To: Bassett Creek Watershed Management Commission (BCWMC)
From: Barr Engineering Co.
Subject: Item 5G: Update on Four Seasons Mall Area Water Quality Improvement Project (2013 CIP NL-2) – BCWMC November 20, 2024 Meeting Agenda
Date: November 14, 2024
Project: 23270051.62 6000 623

5G Update on Four Seasons Mall Area Water Quality Improvement Project, Plymouth (2013 CIP NL-2)

2023 Project

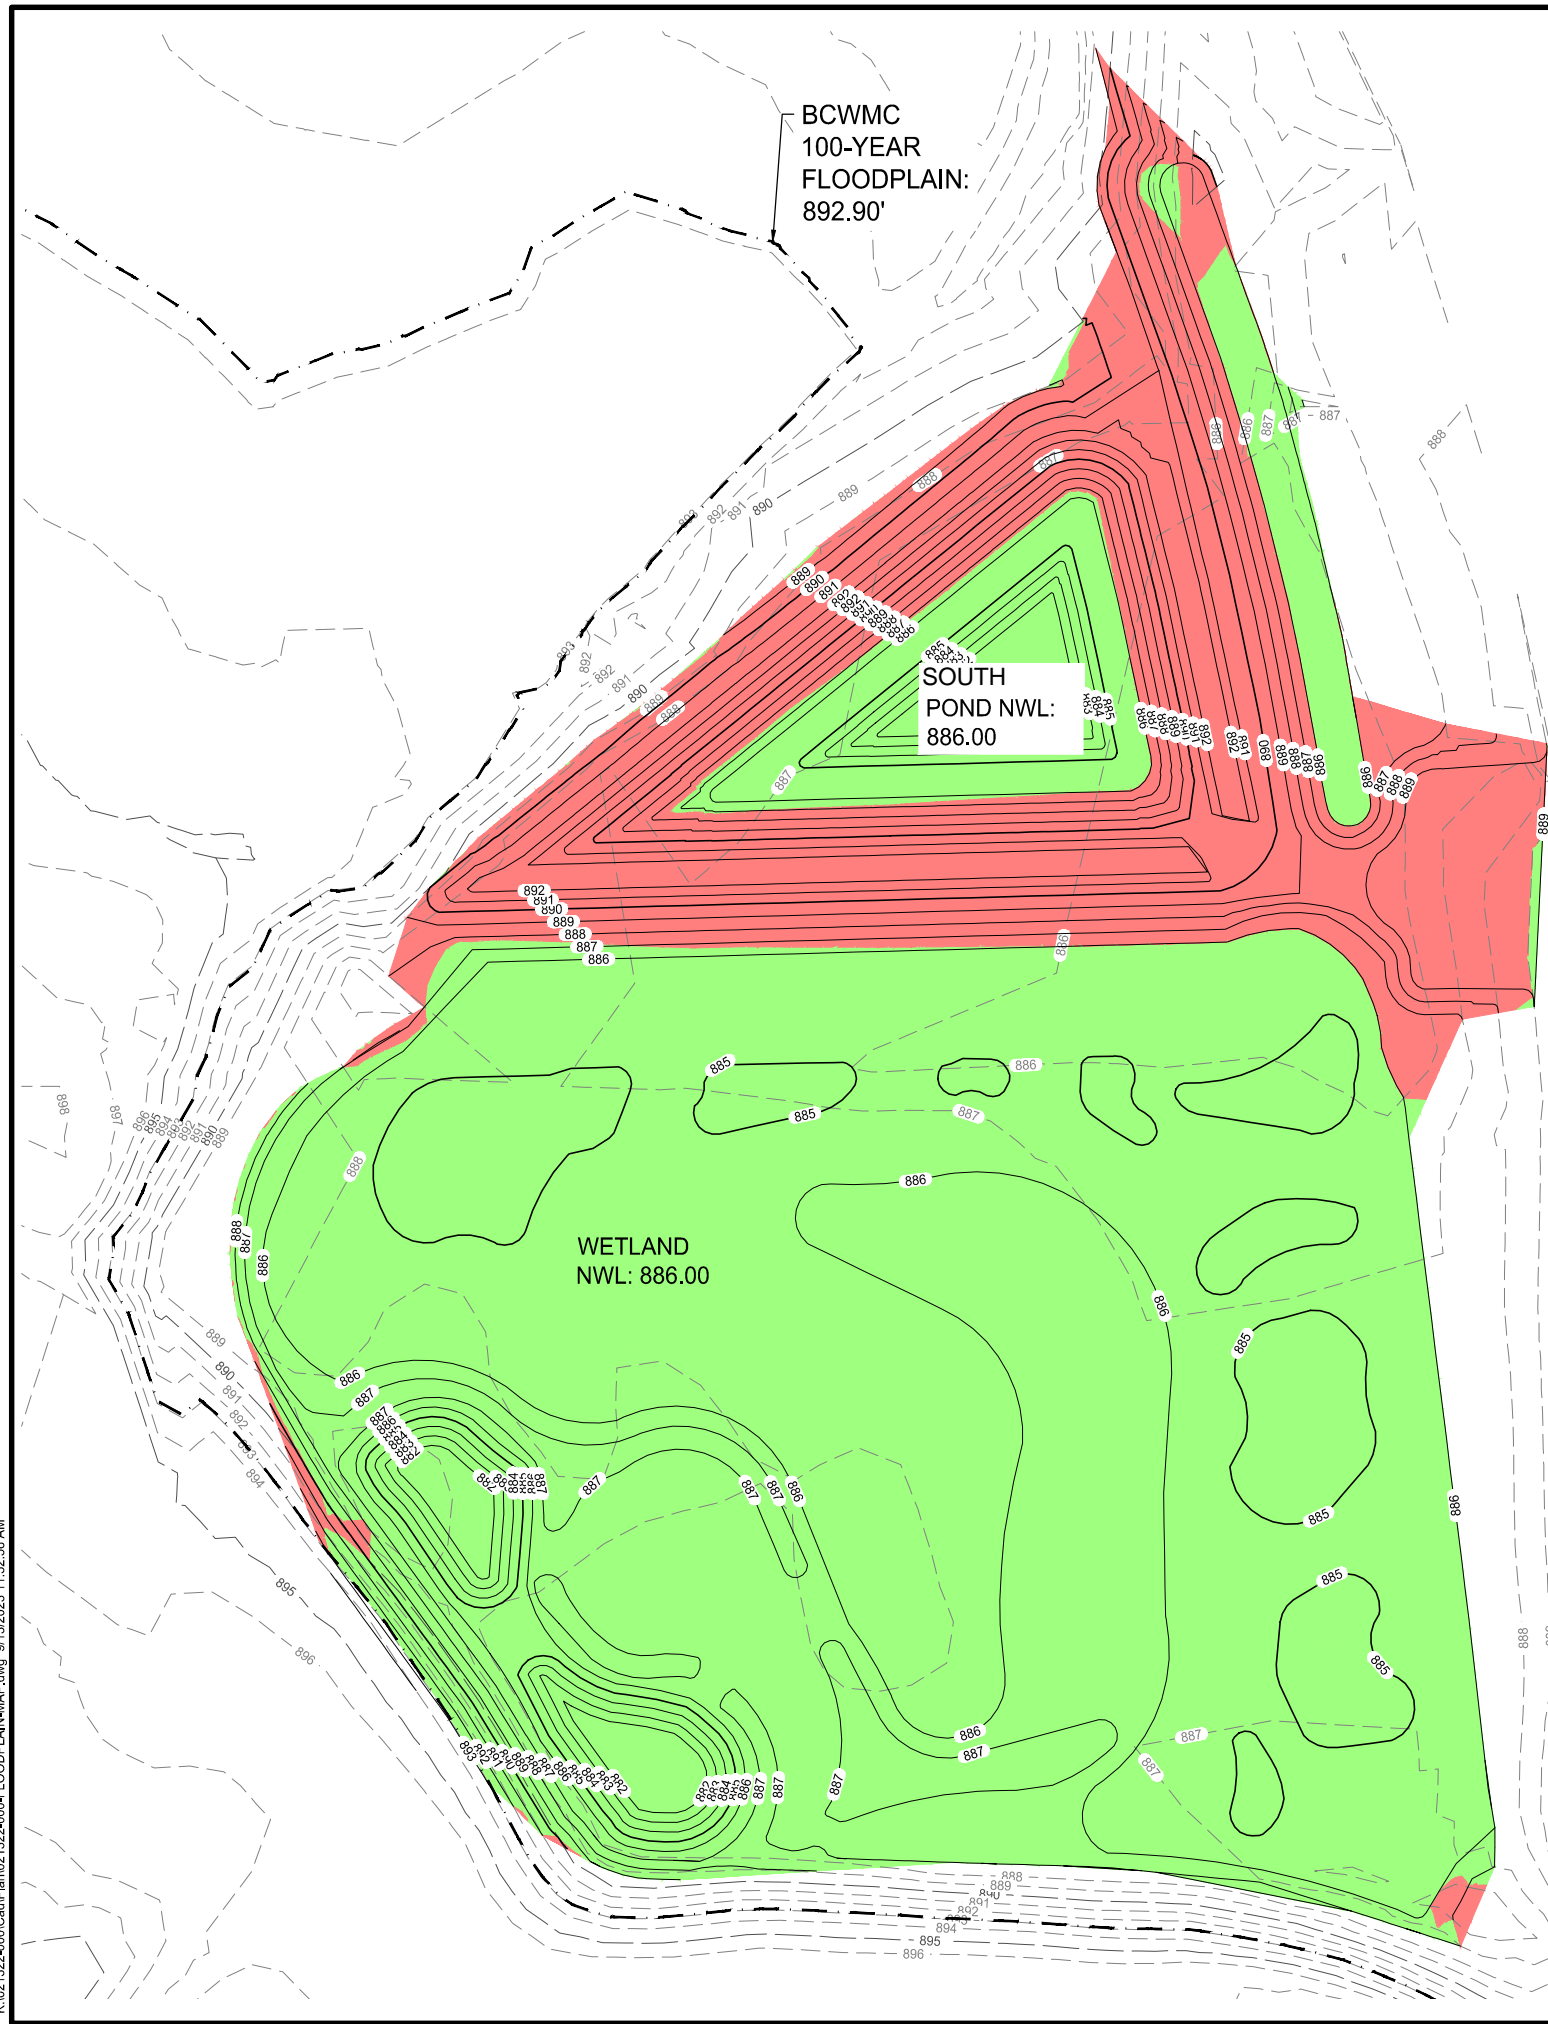
The conditionally approved 2023 Project plans would have resulted in a net increase in floodplain storage of approximately 0.70 acre-feet from the pre-demolition condition. The 2024 Project plans will result in an increase of 4.3 acre-feet of floodplain storage. This additional increase in floodplain storage is primarily due to the removal of a berm around the proposed South Pond (renamed as the North Wetland for the 2024 Project). The attached floodplain exhibits identify areas of cut and fill for the conditionally approved 2023 Project plans and the 2024 Project plans.
